Part 1 of 3 - Summary of Meeting #1 Discussion Guide

Collected via Discussion Guide from Joint BLPC and PFRC Meeting #1, input from Jan. 19 through Feb. 2

Published on February 10, 2022

Preliminary Site Diagram

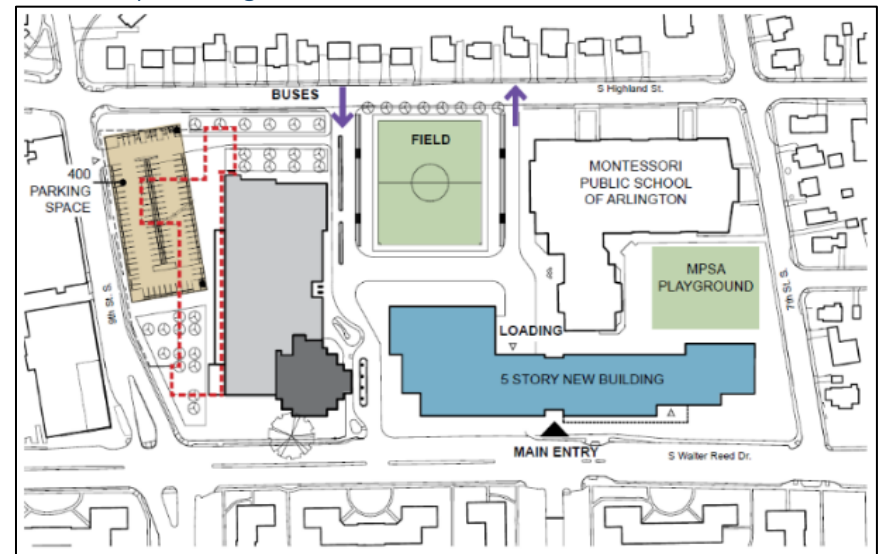
Likes	Dislikes	Information/Suggestions
Support higher density to make more open space, support comment about adding, not on edges	Park & Rec Commission – need to consider quality of open space when evaluating building height. Proposed open space quality does not match mass of proposed building.	The Heights building is taller than 4 floors, would be helpful at follow up to hear how height impacts building flow; Accessibility needs to be addressed
Building up along Walter Reed seems appropriate because it maximizes the use of space adjacent to higher density buildings and allows for green space to be concentrated across the street from the single-family residential areas.	5 story building will tower over Walter Reed and will dwarf residential houses in the neighborhood, not in favor of increasing height	Concerned that having an empty building there long term is unsettling for the neighborhood.

Prefer massing adjacent to main entrance (across from 8th street) or south portion – prefer north end of building lower	Concern about proximity to HS students and K-5	Loading dock is a critical function of the school – more accessible along Walter Reed. Place next to autotech and let autotech draw people in with more prominent location maybe along Walter Reed -- think of car dealerships - how garage doors can be appealing. Placement of loading dock in center of parcel decreases flexibility as buildings/fields come or evolve.
Allows all programs to remain and some to continue throughout construction.	Concerned how the new school building is hiding entrance to Montessori school	Ensure buffer space and attractive streetscape in front of building to protect students and visitors from traffic on Walter Reed
Supportive of the location of the main entrance on Walter Reed		Support higher density to make more open space, support comment about adding, not on edges

Take advantage of sunlight and heating/cooling measures.
		Concern about shadows from the taller building shading MPSA & playground
		Hoping primary massing height was on corner of Walter Reed and 9th – better if building was consolidated in that area

Likes	Dislikes	Information/Suggestions
there seems to be an 'okay' with the height, but the bigger concern is the massing location. Many feel that the height is fine	Height of the building is out of place for the neighborhood.	I think the building should be taller if it means more green space. Super important for the kids to have fields that are accessible even if it means a taller building.
The terracing brings interest and a more airy atmosphere to the building.	High school will literally overshadow MPSA.	From the drawing it appears that the building is not using ground at the corner of S. Walter Reed Dr. and S. 7th St. that will not be used for outdoor recreational space. If using that space would enable the building to be shorter it might make the neighbors happier.
	A taller building is harder to evacuate, a particular concern for people with disabilities, who are often less mobile.	Further tier the section of building closest to 7th St. S & WR, scaling 3-4 stories so as not to completely dwarf MPSA of natural light.

If additional height in exchange for more open space is warranted, consideration should be given to more height toward the 9th St. side of the building.
		Consideration should be given to using glass in the upper floor(s) to allow light pass through and (hopefully) visually diminish the height of the building.
	The new Career Center building should be designed as if the full complement of 1,800 students will use it someday.

Likes	Dislikes	Information/Suggestions
Don't waste land and build low. Utilize space – contingency planning, long-term (30 year+ outlook)	Elementary school dwarfed by high school building. I don't have any easy solutions, but the design seems to take away the light and space that make this elementary school space so inviting.	Elevators. Ensure the new, five story building has at least 2 if not 3 elevators. That is a tall structure.
If additional height in exchange for more open space is warranted, consideration should be given to more height toward the 9th St. side of the building.	5 stories already seems quite tall for the current neighborhood	Suggested that consideration be given to using glass in the upper floor(s) to allow light pass through and (hopefully) visually diminish the height of the building

Likes	Dislikes	Information/Suggestions
Location of parking structure makes sense given the layout of the rest of the site. The parking garage accommodates many uses other than just the Career Center.	Distance from the garage to ACC and MPSA	Safety, in the garage (lighting/sight/access/etc) & going to schools.
Current option is closer to Columbia Pike, which makes it easier to get in and out of the site	Intersection at 9th & Highland challenging w/volume of traffic	Accessible parking and access need to be incorporated.
Location of garage fits into neighborhood the best of the options previously reviewed	Placement seems unfair to residents on S. Highland St.- screening will be important	Solar panels ready for all buildings including garage and look to make top floor flexible to solar or green roof.
Existing ACC serves as a barrier between the proposed new building and the MPSA building.	Left turns from/to NB Walter Reed at 9th difficult during rush hours (intersection difficult)	They under parked TJ? and required teachers to enter parking lottery. Teachers left and they're having trouble getting substitutes as well. It's unaffordable for teachers to live nearby.

There is an existing parking structure across the street, which makes the location of the proposed new parking structure logical	Drop off and congestion currently on Highland Street and parking garage will add to this. 400 parking spaces seems pretty high. Only 200 parking spots at Wakefield with 2200 students.

Likes	Dislikes	Information/Suggestions
Location works, it is balanced by another large structure across 9th St. S	Parking is not adjacent to either building, and it is unclear how users will access parking from either building, as the current Career Center building blocks access.	want to know with certainty that the proposed garage on 9th Street meets the volume requirements for students and teachers of both MPSA and Career Center programs.
Fully support APS providing adequate parking onsite for staff/student/visitor needs.		MPSA/library needs their own designated parking, such as ADA, short-term visitor and

potentially some staff spots closer to its location.
		There are concerns about how traffic will exit the parking structure: desire is that traffic not exit onto S. Highland Street, which is very narrow
		Be sure space in the structure includes space for cars needed for the Auto program at the Career Center
		safety - the more people that use this space the safer it will be. I am imagining walking to the garage on this campus after dark by myself and it's not a pretty thought based on this design. 9th Street is already scary-desolate.
		Perhaps consider a 'hybrid' approach with part of the structure sunk in to minimize the number of above ground floors that are needed, and perhaps reduce the overall footprint of the structure.

Likes	Dislikes	Information/Suggestions
the 9th St and Highland St. section of the property, with the long side orientation of the garage on 9th St (as proposed), is the best location for the garage	Very shortsighted to put above ground because of expense. It will be regretted.	Wherever you place the parking lot, please make sure that there is enough parking in it for ALL of the staff who work at the sites as well as for many students.

Likes	Dislikes	Information/Suggestions
I like the location given the limited options and I realize we can afford more levels if it is above ground.	9th street garage seems far away from the new building and from MPSA.	Entrances and exits from the structure should be on 9th St. and there should be at least two entrances/exits each.
	This will make 9th street look very unappealing and create a dark cold unnecessary feel.	Could consideration be given to undergrounding some portion of the garage for handicapped usage and tunnel access to all buildings onsite

Likes	Dislikes	Information/Suggestions
Goals are right, sensitive about overloading the street.	Seems like residents on S. Highland St. are taking all of the burden from this project with traffic. This is a residential street that already has congestion and problems with PU/DO for MPSA.	Accessibility targets need to be addressed explicitly for both the building and for transportation
Those are the right goals. Schools suffer from attracting quality teachers when parking is not available.	Glad that this has been declared an option school site, however option site will dictate more APS school buses most likely, thus increasing traffic to the school	Consider using or expanding the ART Bus system for students and teachers and others visiting the center; Need to be thoughtful about location of public bus stops/shelters as the shelters take up significant real estate
Buses for MPSA and ACC visit the site at different time	Concern that multimodal transportation is difficult and need to improve routes for bikes	Possibly elevate fully supporting use of alternative transportation modes to ACC to a goal

Buses come to the site during arrival and dismissal (8), but also shuttles throughout the day (7 or 8 buses). Flow now works well, biggest issue with current setup is confluence of parent PUDO in bus loop as opposed to designated location on Highland. School likes proposed plan since bus traffic only comes onto the site and parent PUDO is off site, doesn't mix buses and cars	Concern about traffic from site along 7th to Glebe Road and access at Glebe/arteries	Understand most teachers have to commute by car but we should look at minimizing the amount of traffic coming in.
		An issue is the way buses come back out on Highland. The queuing of cars, with buses turning, that will be a problem. Add that to a concept that needs to be fixed. Maybe Highland be one way?
		(LIBRARY) Will there be sufficient parking for quick drop off for books? Can there be temporary spaces/short term parking on Walter Reed or 9th street for quick drop off of books?

Likes	Dislikes	Information/Suggestions
These are the right priorities	The new Career Center plan further will increase traffic along Highland, either to access the campus via the U lanes or to access the proposed parking garage.	Have buses exit onto Walter Reed and put a traffic light at that intersection
	Plans must ensure that there is sufficient room for bus PUDO to occur and get past loading dock areas, WHILE loading areas are being used.	As staff considers options to minimizing traffic impacts caused by the APS facilities at the site, the safety of those accessing the CP Library (and the vehicular traffic that may generate) needs to be addressed as well.
		Add teacher retention to the list. Teachers do not want to work where they can't park and substitutes don't want to accept assignments if they can't park either
		Incorporate ample bike parking and Safe Routes to School (e.g. safe crossing for Walter Reed and other streets) for walkers.

Please add ADA accessibility to the list. Fleet struggled with lack of accessibility for disabled students, and we do not want to repeat that failure of design.
in addition, adequate parking on surface streets/WR should be identified as part of all 3 of these goals.

Likes	Dislikes	Information/Suggestions
I agree with these goals.	Traffic in the neighborhoods would be significantly increased causing delays in pick ups and delays in those who live in the surrounding neighborhood to reaching their houses.	The loading dock for the new building is identified, but where are the loading docks for the other buildings onsite? What is the traffic flow going to look like for all loading dock activities?
	neighborhood concerns about increased traffic impacts on Highland St should be addressed.	Question how realistic is it to “emphasize pedestrians, bicycles, and mass transit over automobiles” when determining transportation demand given that all programs on this site are county-wide option programs. By definition, demand for vehicle access will be higher than at other similar-sized campuses.
